TENNESSEE VALLEY AUTHORITY
SEQUOYAH NUCLEAR PLANT

BALANCE OF PLANT TEMPERATURE MONITORING SYSTEM

CHANGE REVIEW CHECKLIST FOR
ELECTRICAL CALCULATIONS

Change Description REPLACE EXISTING LEVEL SWITCHES 1,2-LS-87-21, 22, 23, 24 WITH SQR MODEL # 103HS-BB502-NX-JITT X6

ELEVATIONS FOR UHI (WATER ACCUMULATOR & 1-LS-87-21, 22, 23, & 24)

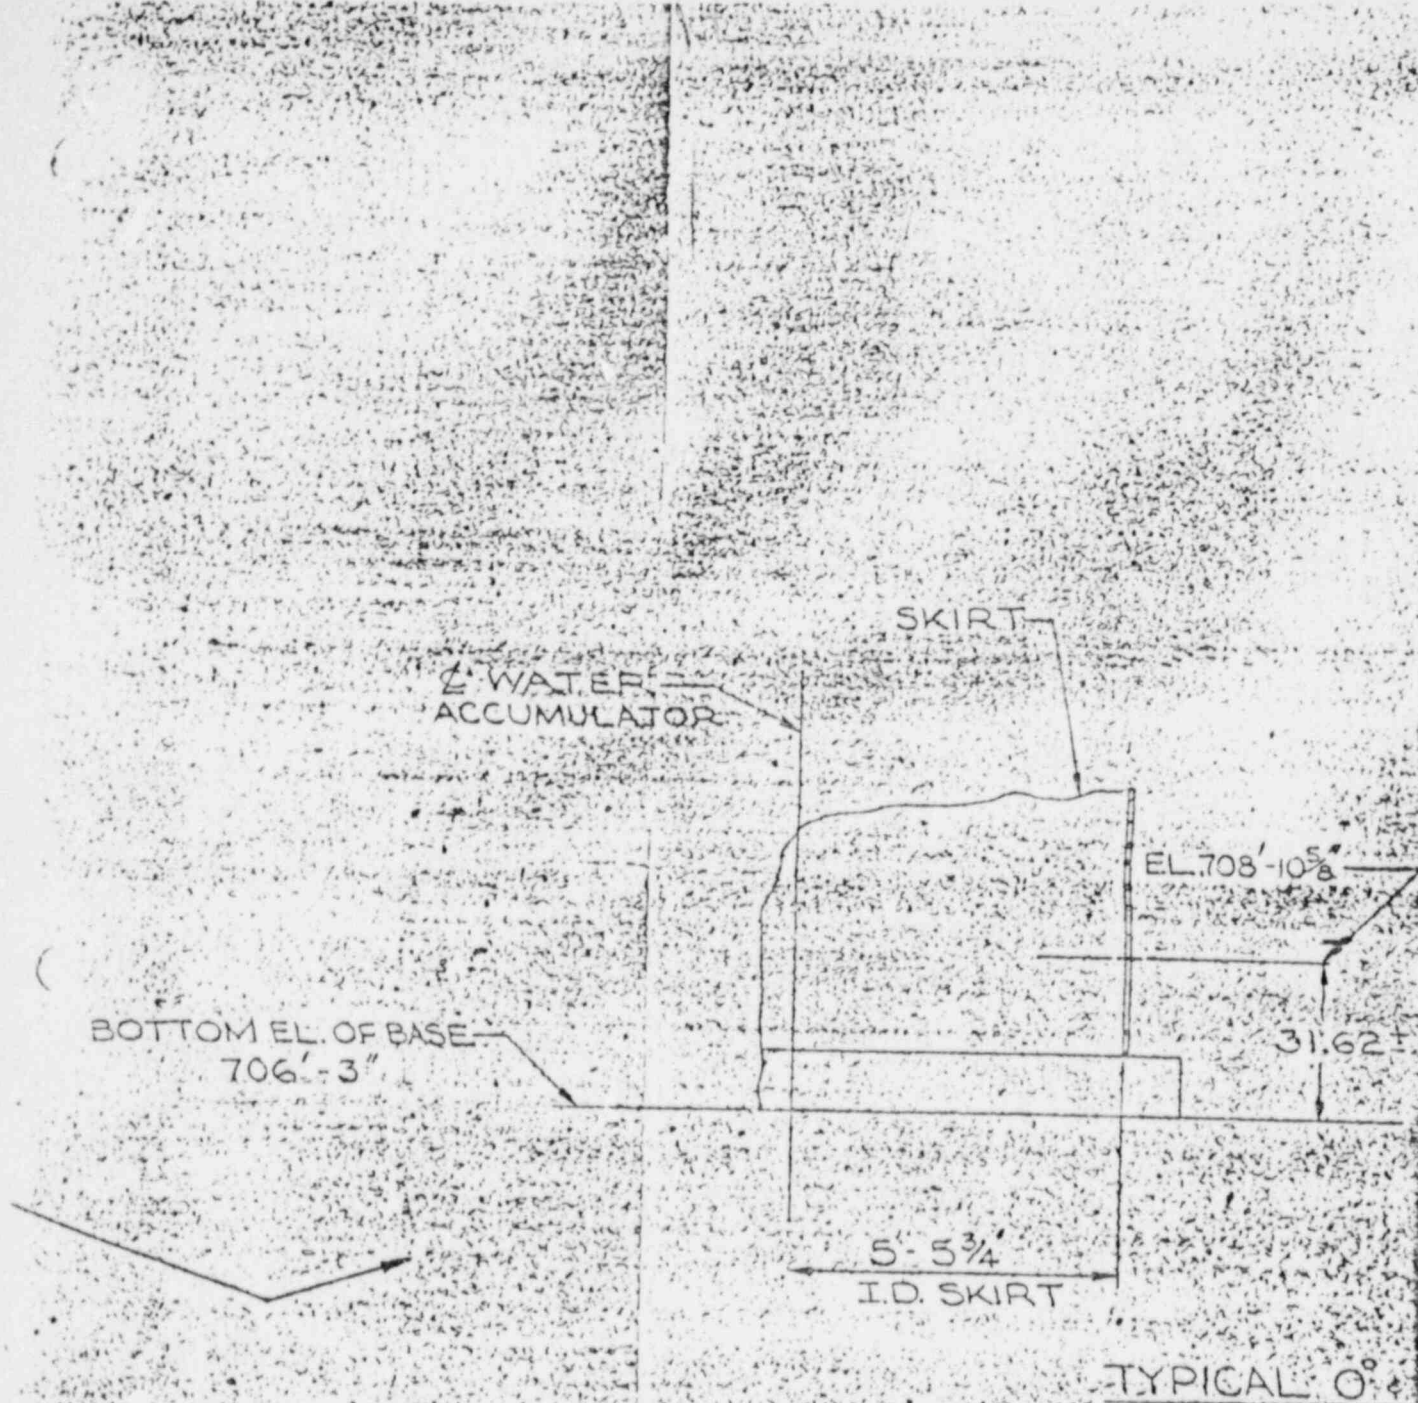
Distance between floor & condensate pots is 29'.
" " " & bottom tap elevations is 76".

Elevations for 1-LS-87-21, 22, 23, & 24 can be seen below:
(distances are between the floor and center line of LS)

LS	DISTANCE
21	52"
22	61"
23	46"
24	58"

Floor elevation is 706'.
